FAQ Number 07-0038

FAQ Title Lessons learned on Multiple Spurious Operations

Plant: Harris

Date: September 20, 2007

Figure XX – Multiple Spurious Operations – Transition Resolution Process

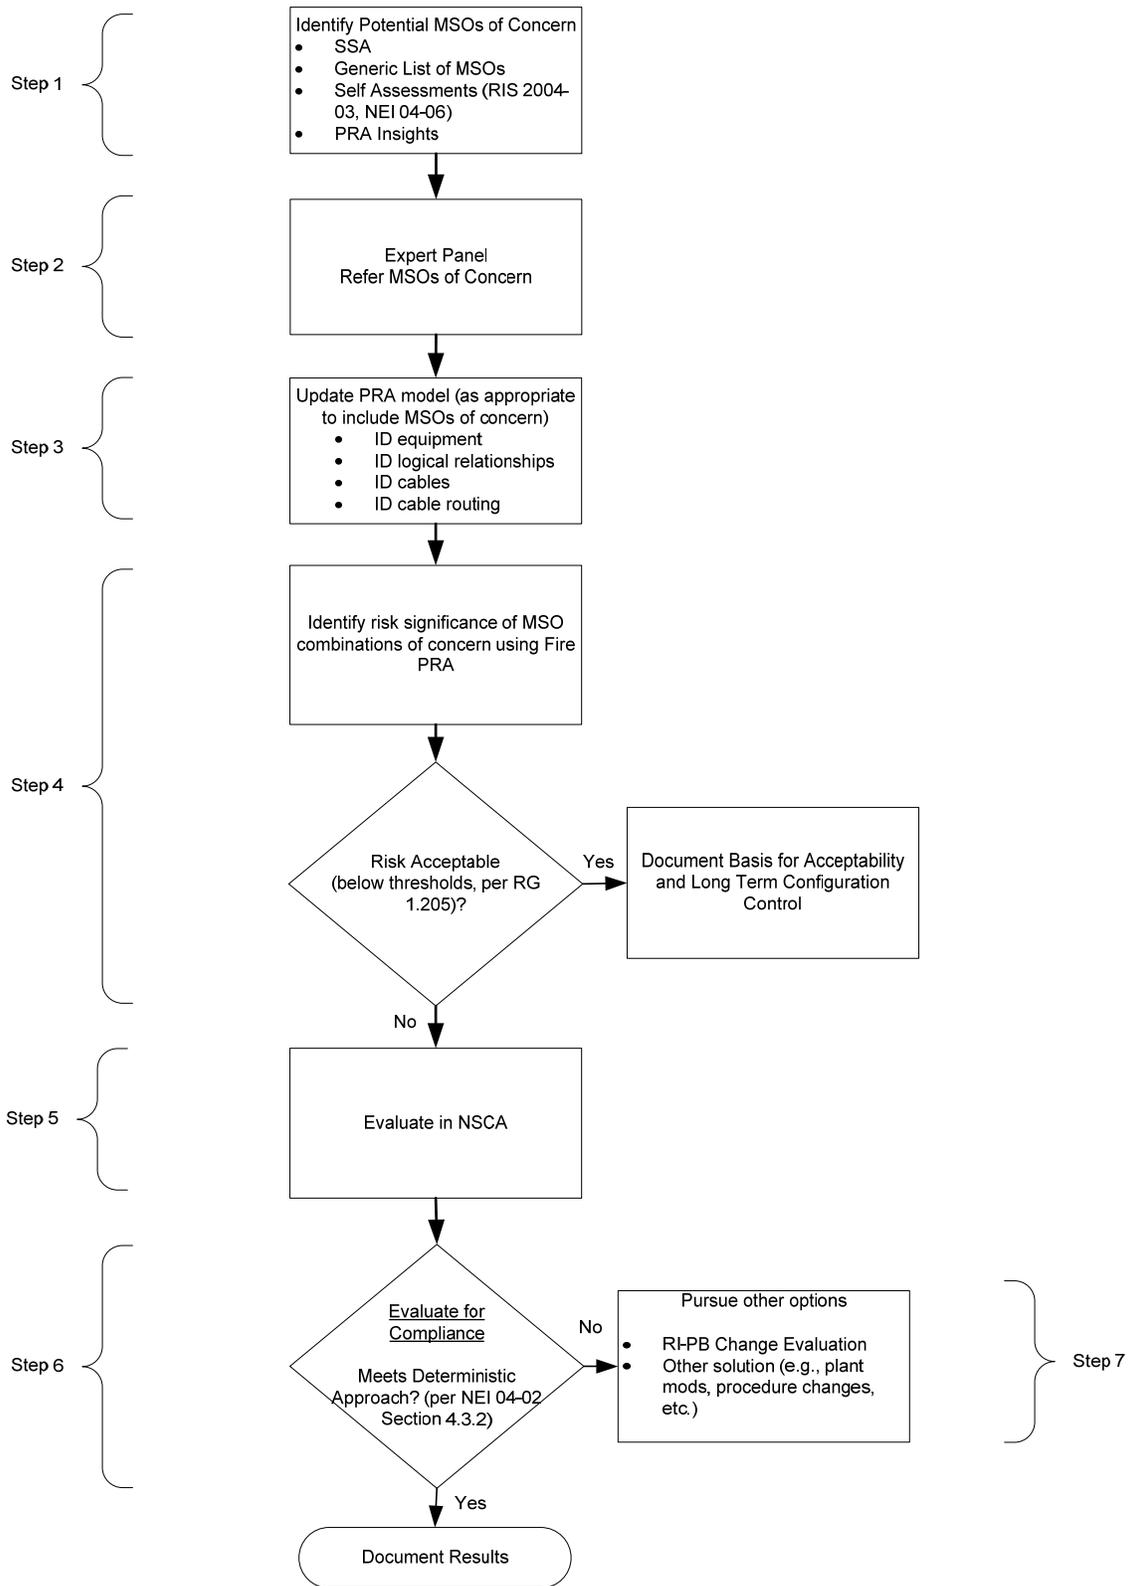
The approach outlined in Figure XX below is one acceptable method to address fire-induced multiple spurious operations. This method uses insights from a Fire PRA that meets the requirements of Regulatory Guide 1.205, Revision 0.

This process is intended to be in support of transition to a new licensing basis. Post-transition changes would use the risk-informed, performance-based change process. The post-transition change process for the assessment of a specific MSO would be a simplified version of this process, and may not need the level of detail shown in the following section (e.g., An expert panel may not be necessary to identify and assess a new potential MSO. Identification of new potential MSOs may be part of the plant change review process and/or inspection process).

Figure YY – NEI 04-02 Section B.2.1 Change in Risk Criteria due to MSOs (Change in CDF Only Shown)

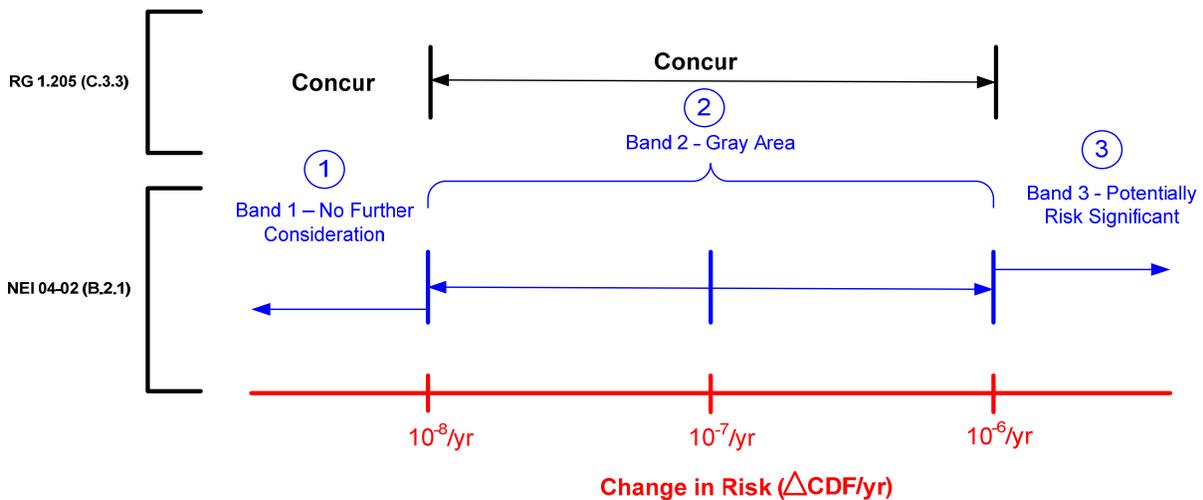
Determine if the risk significance of the MSO warrants additional review / action. The following table and figure provide a summary of risk thresholds that have been reviewed and found acceptable by the NRC for addressing MSOs. If surrogate approaches are used to focus on higher risk scenarios, a CDF value of 1E-08/yr prior to operator response to address the fire-induced spurious operation (LERF value of 1E-09/yr) should be used as a threshold value for the scenarios, consistent with the values for MSOs previously found to be acceptable. Refer to Table XX and Figure YY.

Potential MSOs of concern below the screening threshold (band 1 of Figure YY) do not require further evaluation. The review that was performed should be documented for configuration control. This documentation should include a disposition of items recommended by the expert panel for additional review.

Figure ZZ – RG 1.205 Change in Risk Criteria due to MSOs (Change in CDF Only Shown)

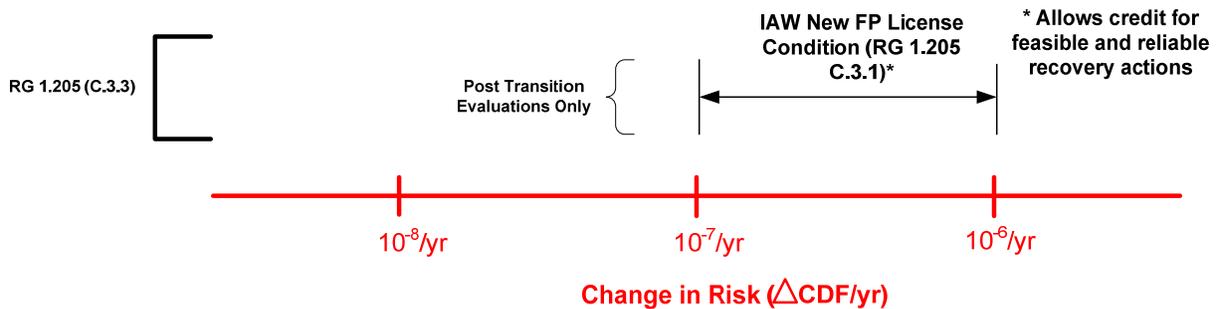
<u>Ref.</u>	<u>ΔCDF</u>	<u>ΔLERF</u>	<u>Characterization</u>	<u>Action</u>
<u>RG 1.205 (C.3.3 and C.3.1)</u>	<u><1E-06/yr but ≥1E-07/yr</u>	<u><1E-07/yr but ≥1E-08/yr</u>	<u>Post transition</u> <u>See Figure ZZ</u>	<u>Post-transition – Process in accordance with FP license condition (RG 1.205 – C.3.1)</u> <u>Allows risk increase to consider credit for feasible & reliable recovery actions.</u>
